MEMORANDUM

Date: August 19, 2015
From: Marie Ennis, Gabriel Pardo
To: John Shedd
Company: Chautauqua Institution
c:
Project: Chautauqua Institution Amphitheater Study: Narrative and Questions
Project #: J3262.02

The following is a brief narrative to accompany the two options for structural work shown in the Old Structures Engineering (OSE) drawings originally dated July 15, 2015. The drawings have been revised to better coordinate with the sequence description narrative, and to address a comment from Wendel Architecture and Engineering regarding helical piles.

A.1 STEP 1 - Longitudinal Section. Grid Lines 2 & 8
Scale: 1/16" = 1'-0"

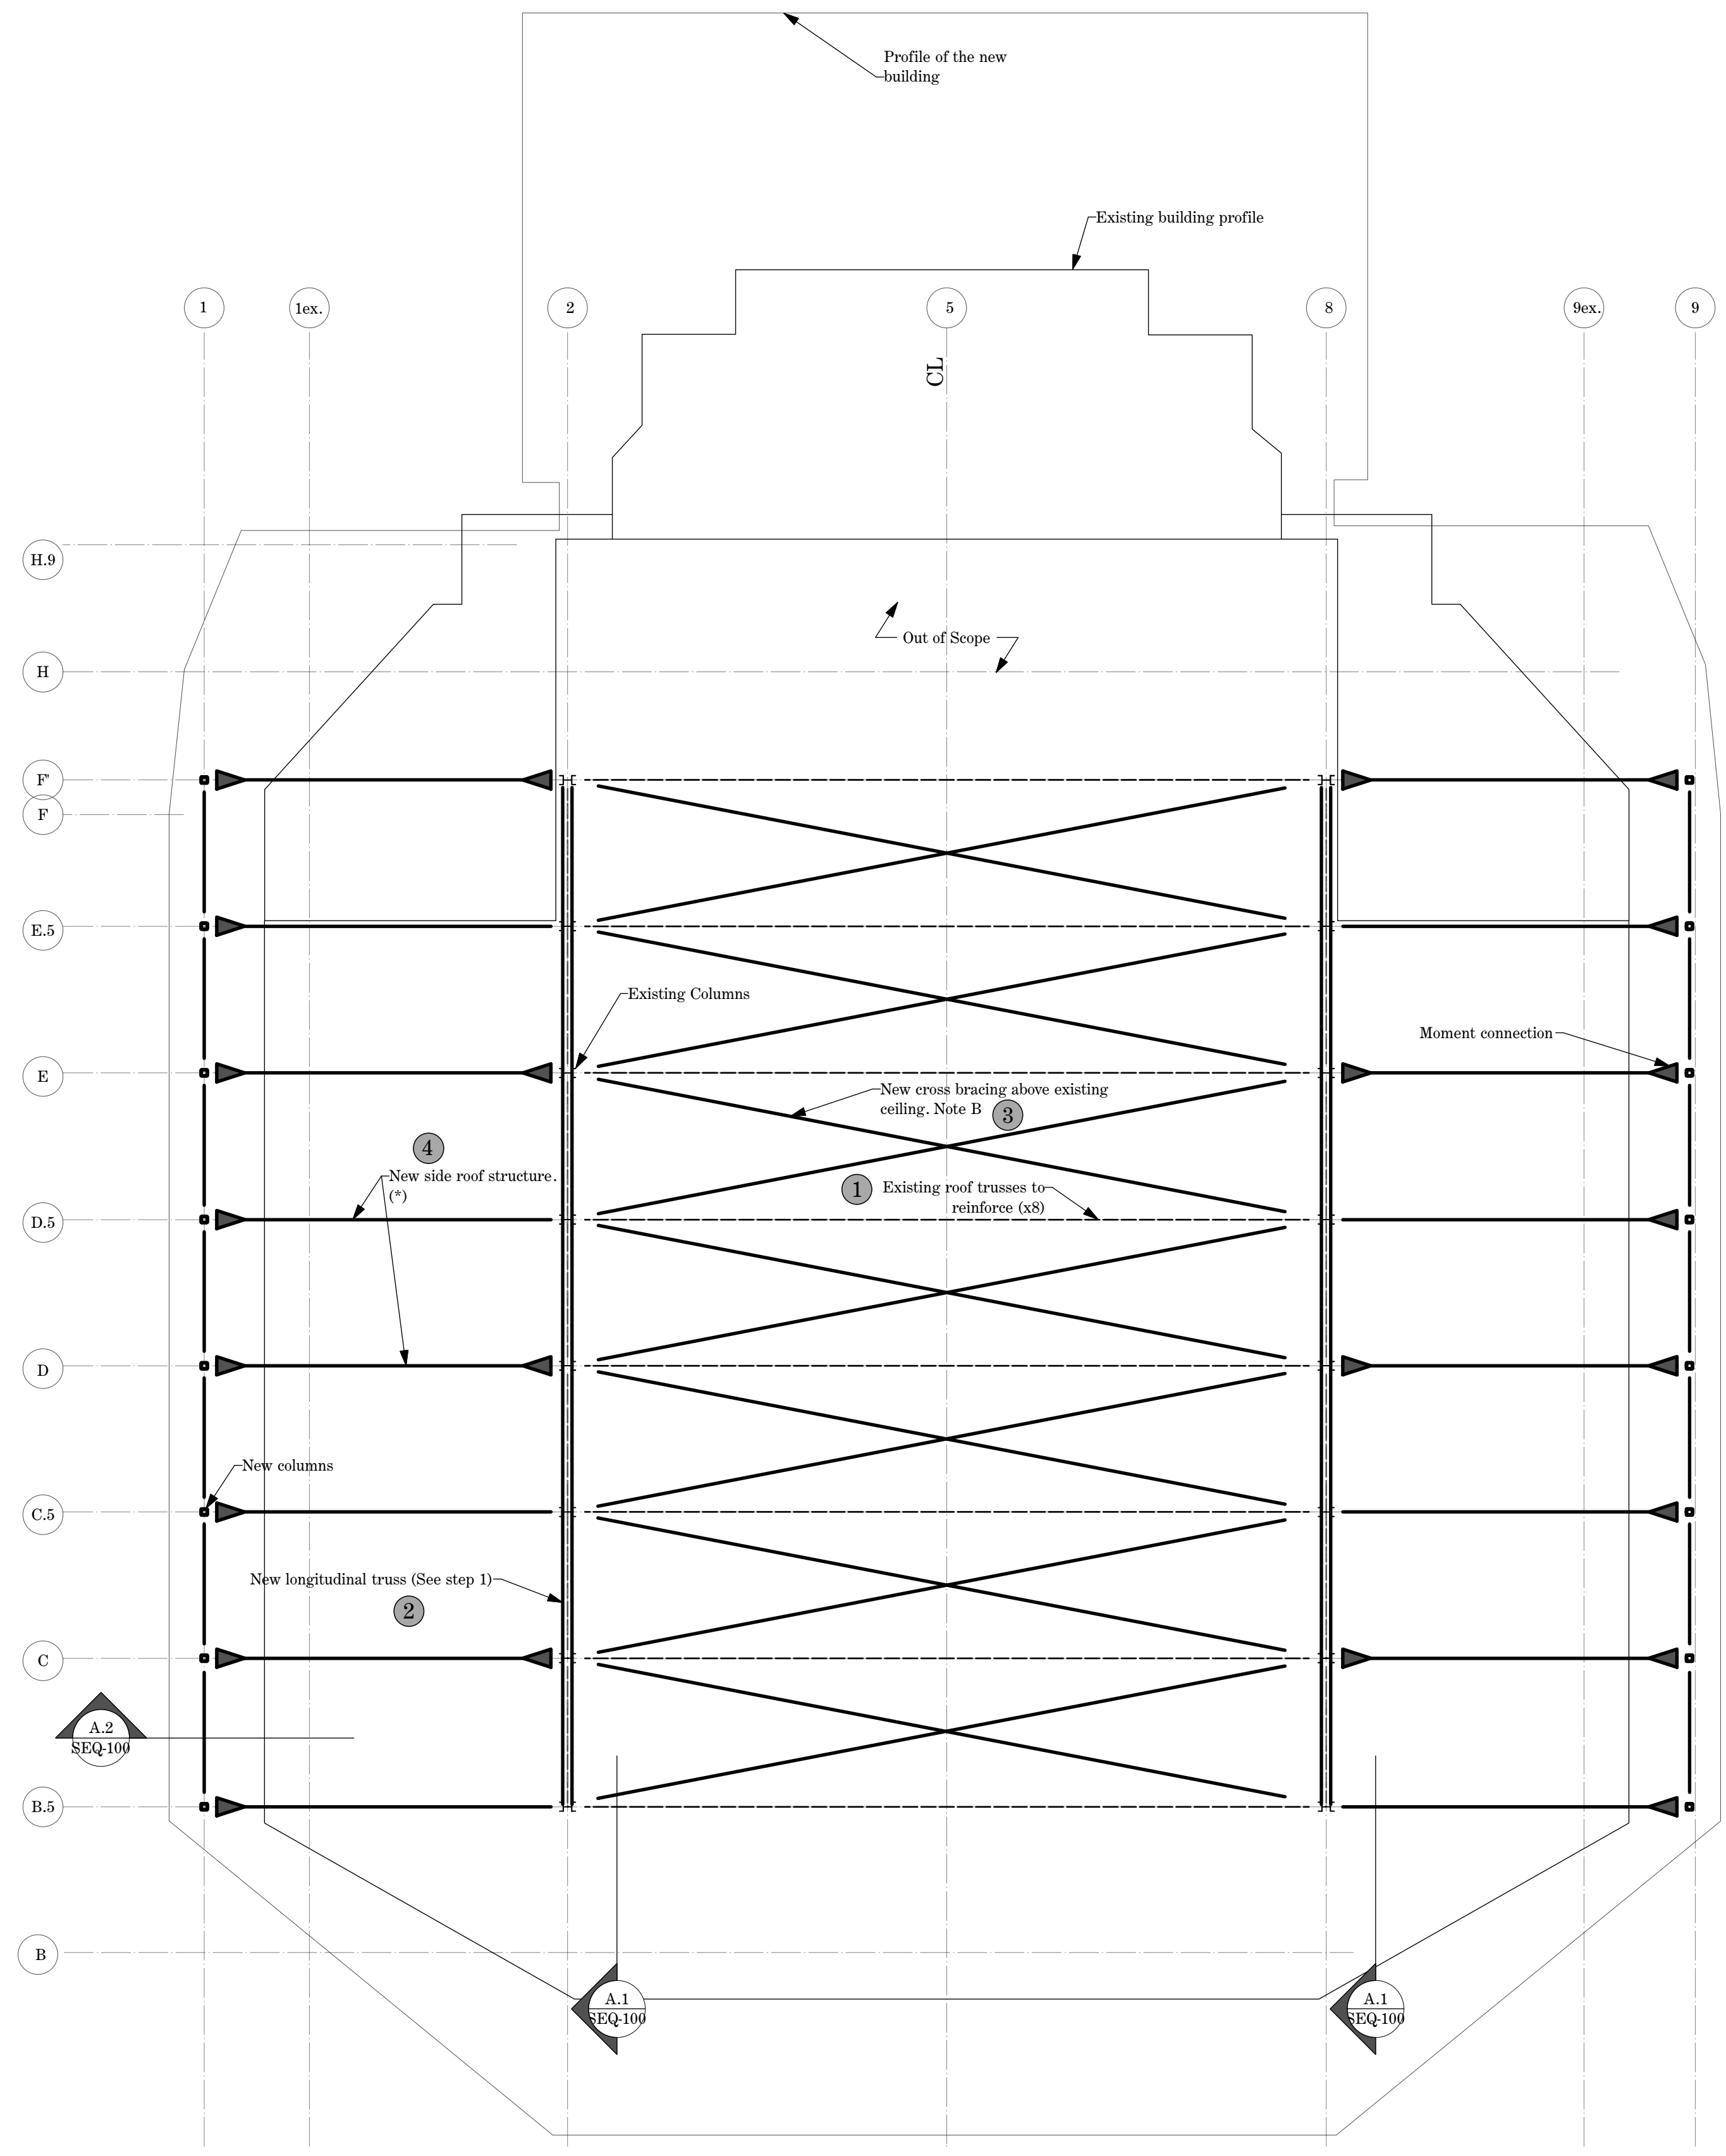
The existing trusses/columns are not uniformly spaced, therefore fabrication and fitment of the new longitudinal trusses will be difficult, and field re-work is likely needed.

The report does not address the removal or shoring/temporary support of the existing “side roof” trusses. To facilitate the installation of the new outboard longitudinal truss, the existing “side roof” trusses must be removed in their entirety or temporarily supported and have enough material removed to facilitate the installation of the new longitudinal truss.

Steel fabrication: Our experience with older steel buildings - their repair and reinforcement - is that each project is unique. The steel work must be clearly detailed, and the steel fabricator must submit shop and erection drawings with sufficient information to demonstrate their understanding of the required work. Ideally field re-work is kept to a minimum; proposed field modification methods need to be submitted for review prior to construction. Staging and rigging will also be critical aspects of the work.

Side roofs: We have revised our schematic drawings and narrative to better describe the phasing and coordination between the longitudinal truss installation and the removal and reconstruction of the side roofs.

A.2 STEP 2 - Cross Section
Scale: 1/16" = 1'-0"

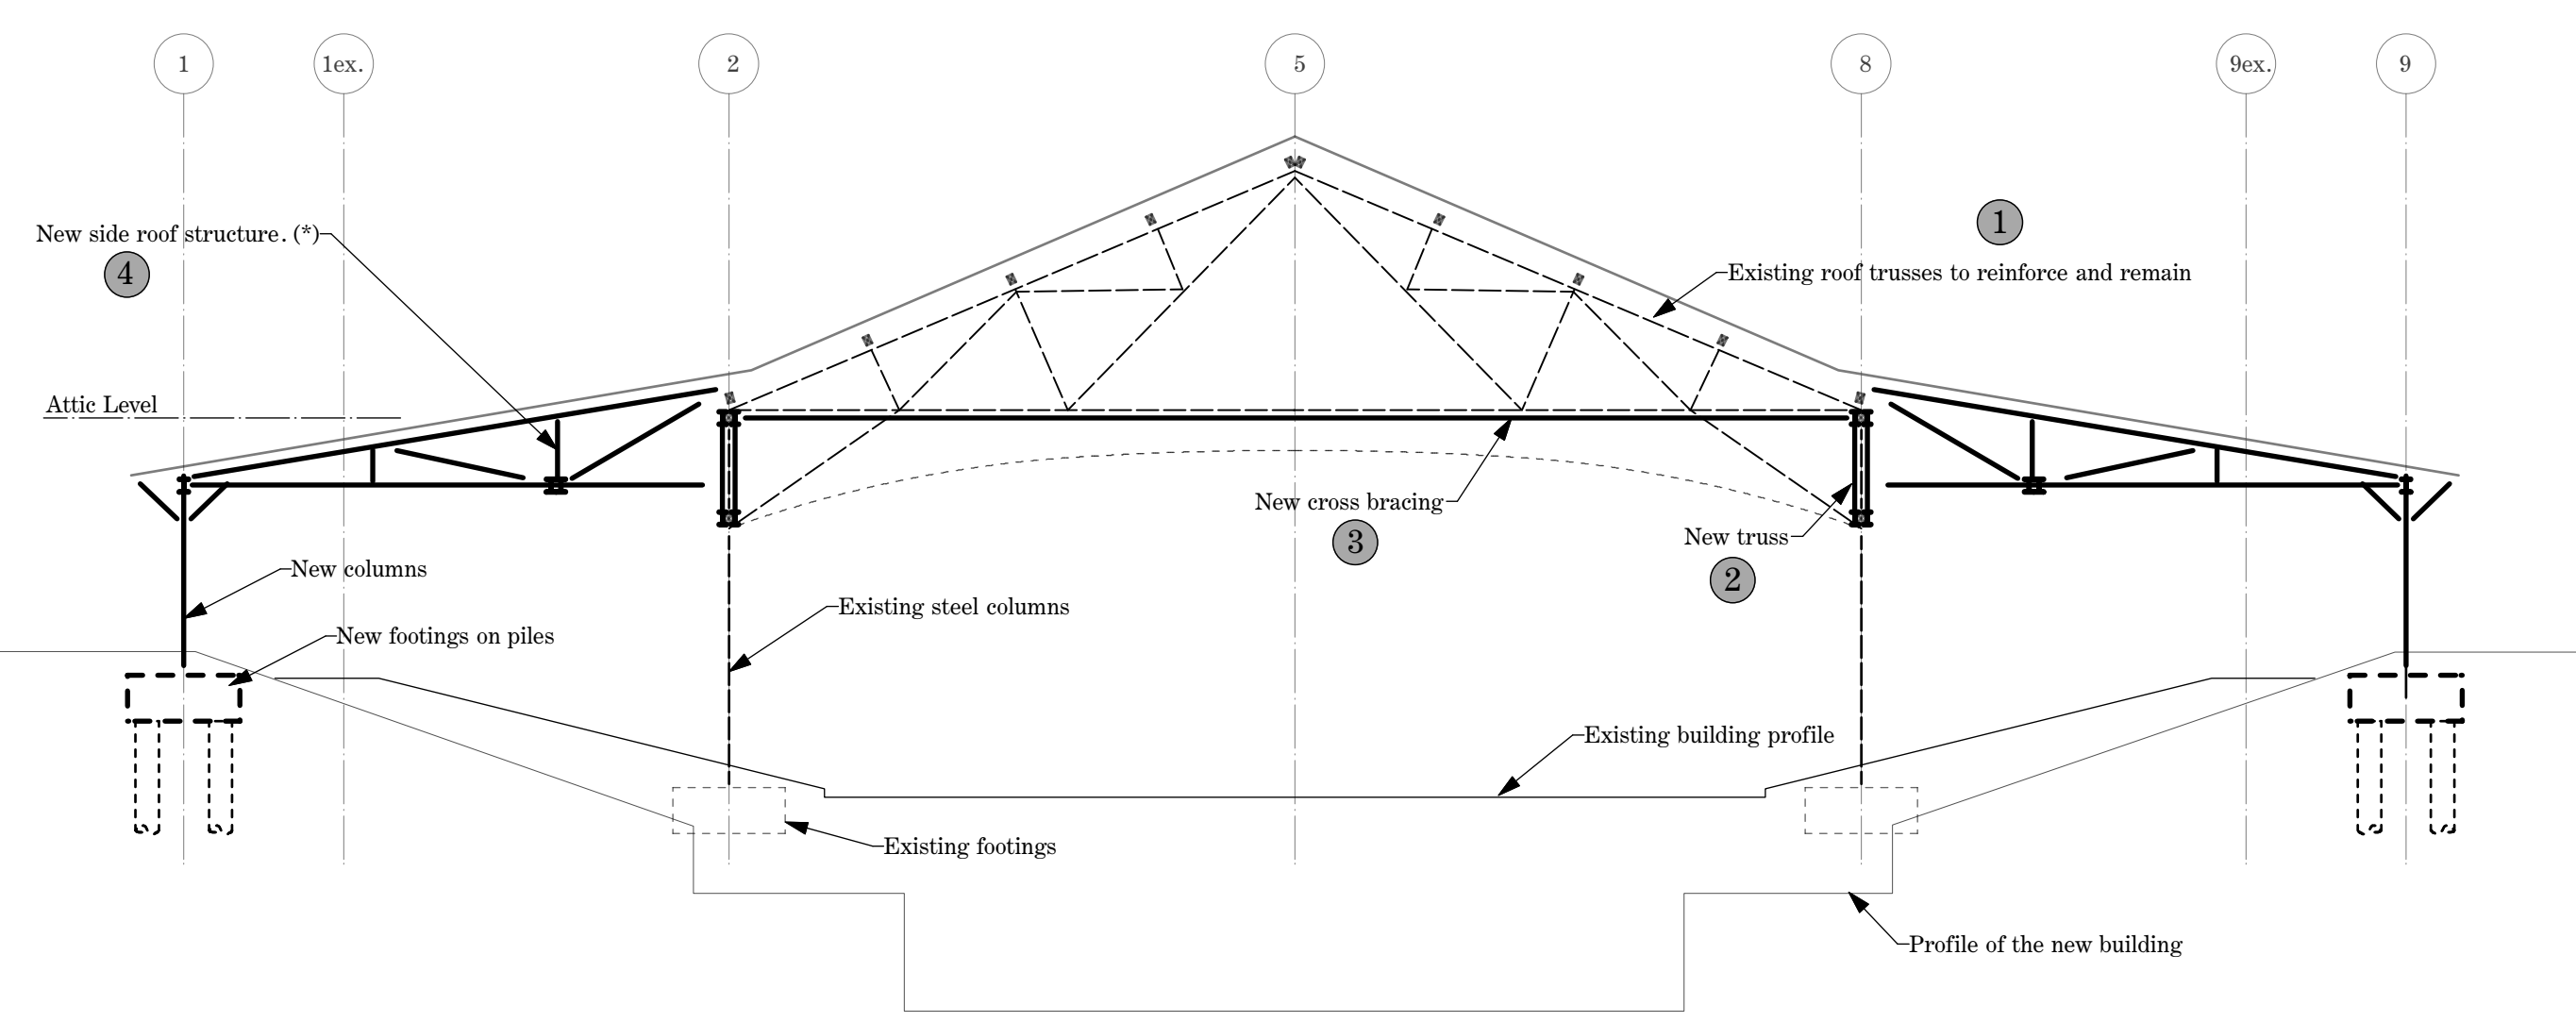
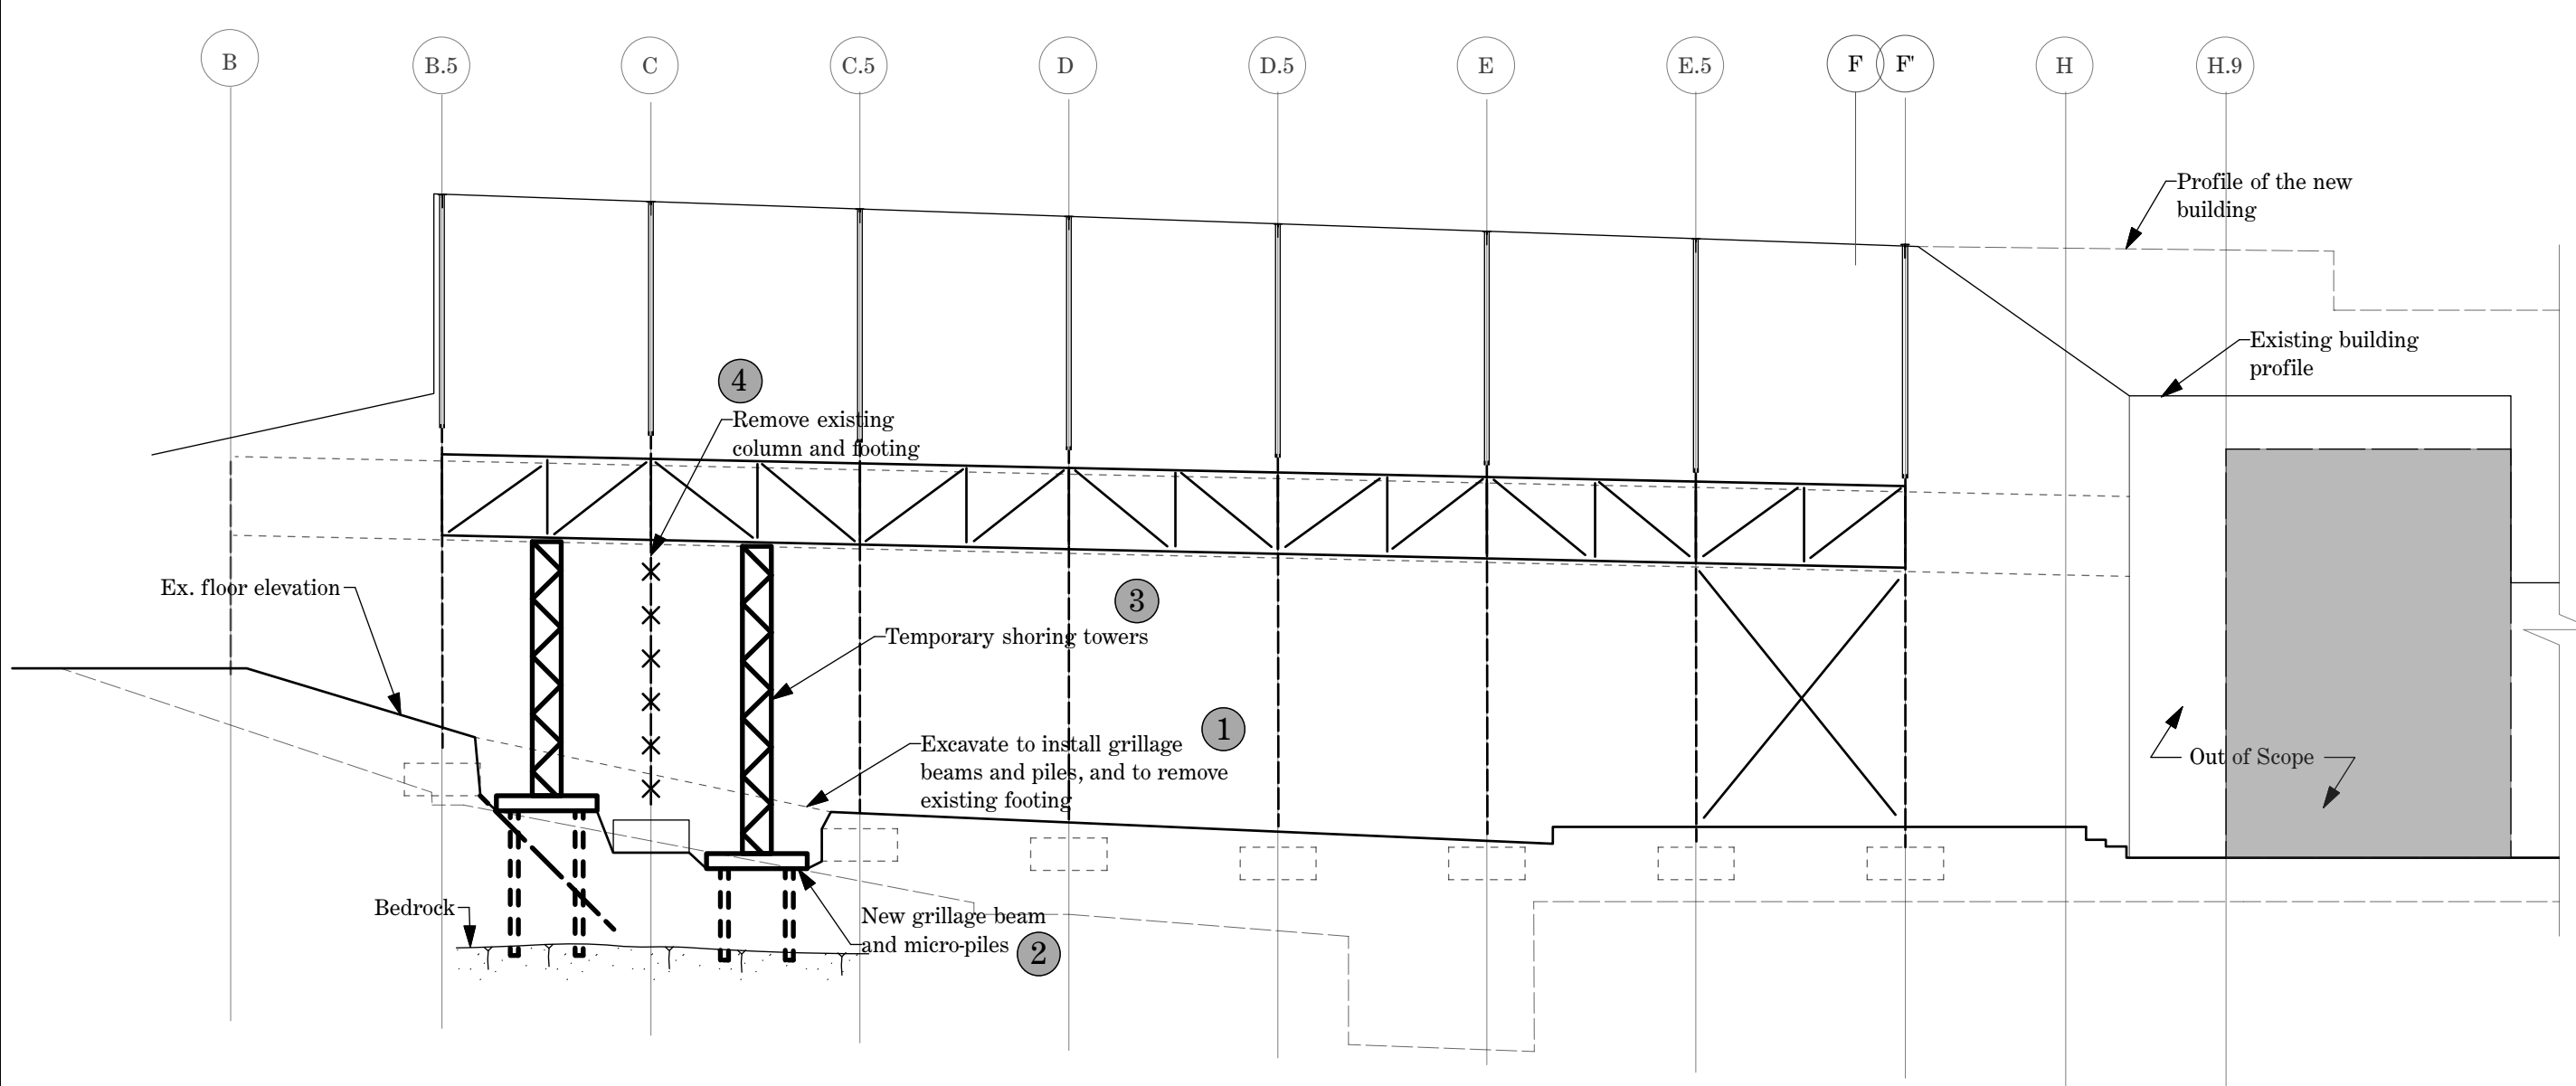
The installation of the new cross bracing above the ceiling will likely be difficult to install physically in place, and will likely require that much of the existing ceiling material be removed.

Yes, at least portions of the ceiling must be removed to gain access to existing and to install new structure. As to the cross bracing, this work is similar to some of the retrofit previously installed in the amphitheater attic (e.g., Albert Kreutter circa 1978), so it is feasible.
